RE: **EM-CING-075-210114** – New Cingular Wireless PCS, LLC (AT&T) notice of intent to modify an existing telecommunications facility located at 156 Sterling City Road, Lyme, Connecticut.

Re: New Cingular Wireless PCS, LLC ("AT&T")
Exempt Modification Acknowledgment
EM-CING-075-210114
Emergency Back-up Generator
156 Sterling City Road, Lyme, CT 06371
Lat.: 41.37729°; Long.: -72.34600 °

**SITE NAME: LYME CENTRAL
FA LOCATION CODE: 10071096**

GENERATOR PROJECT 30KW GENERAC DIESEL GENERATOR 200A GENERAC ATS

SHEET TITLE:
 SITE PLAN & EQUIPMENT LAYOUT

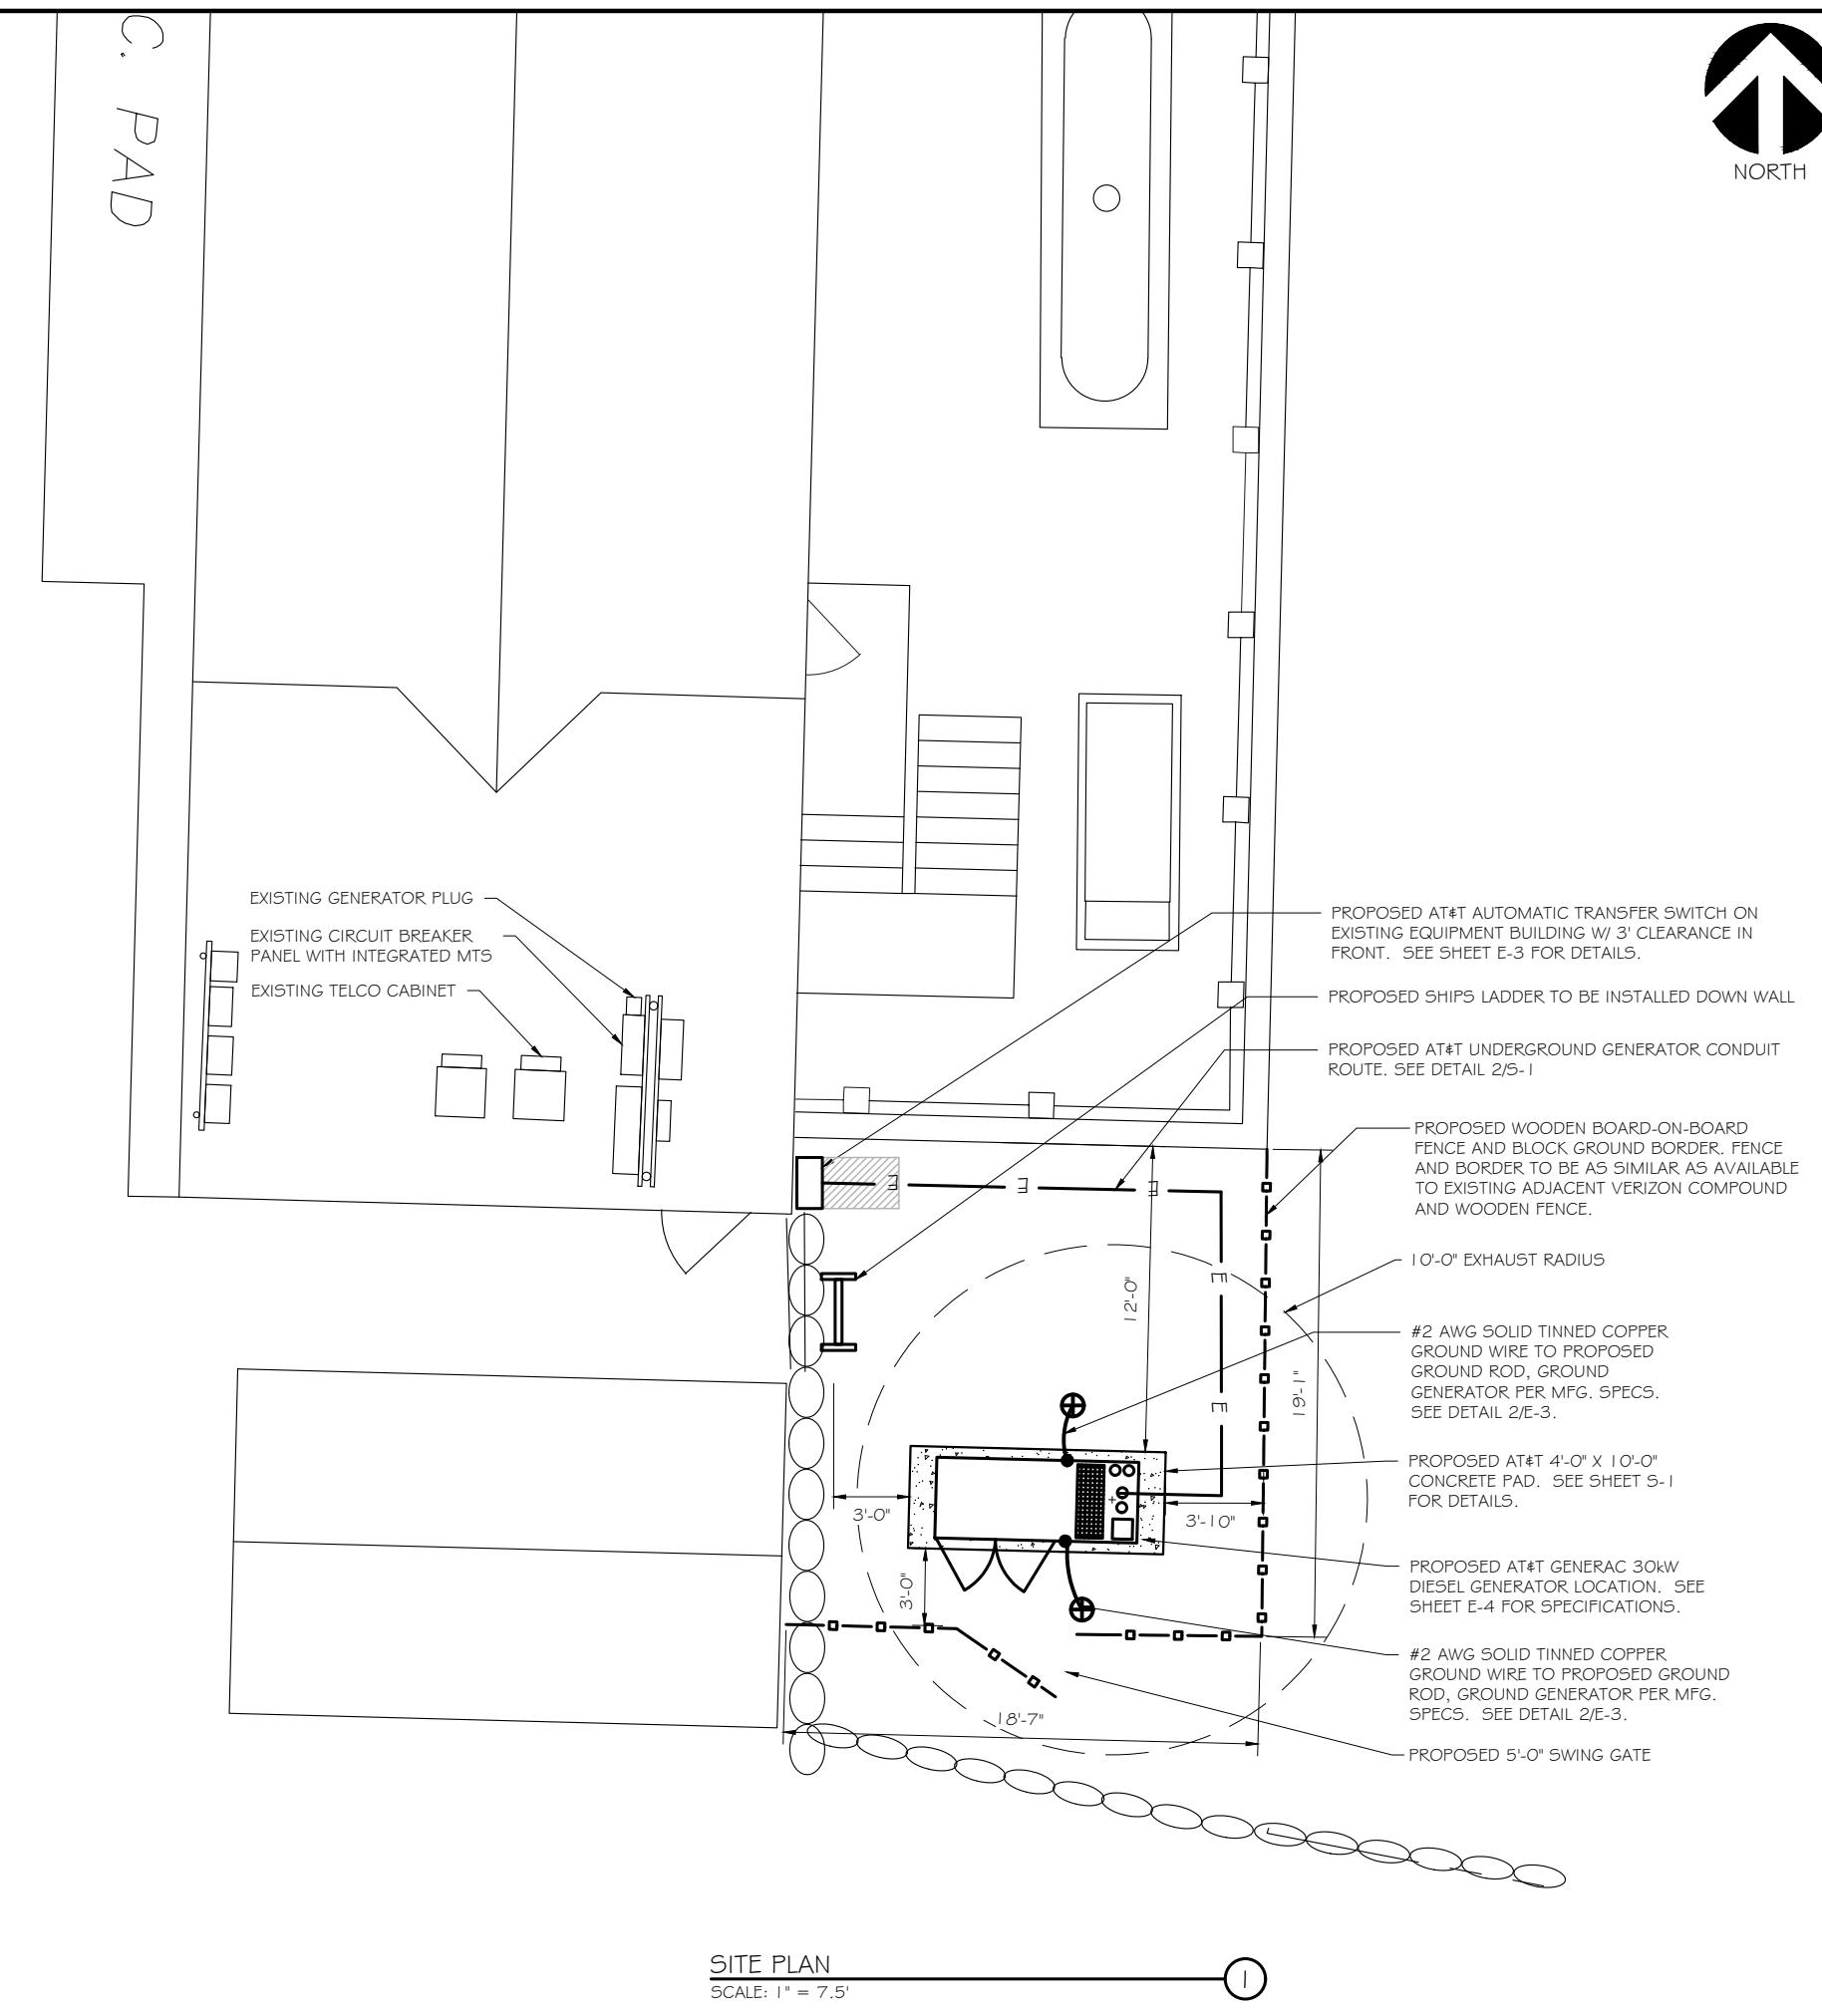
The request to change the approved 10-foot by 15-foot fenced area to 19-foot one inch by 18-foot seven inch fenced area for the generator, is hereby approved.

Subsequent to AT&T's Notice of Exempt Modification filing, the owner of the underlying property and silo, the Estate of John J Tiffany II (c/o Susan Tiffany), requested a modification to the location of AT&T's emergency back-up generator. To accommodate the property owner's request, AT&T revised the extension of the fenced grade-level equipment compound from 10' x 15' to 19'1" x 18'7" as shown on the plans enclosed and dated March 4, 2021. All other details of the generator installation remain the same. The proposed extension is located within AT&T's lease area and as such, it meets the definition of "site" provided in the Regulations of Connecticut State Agencies ("R.C.S.A.") Section 16-50j-2a(29).¹
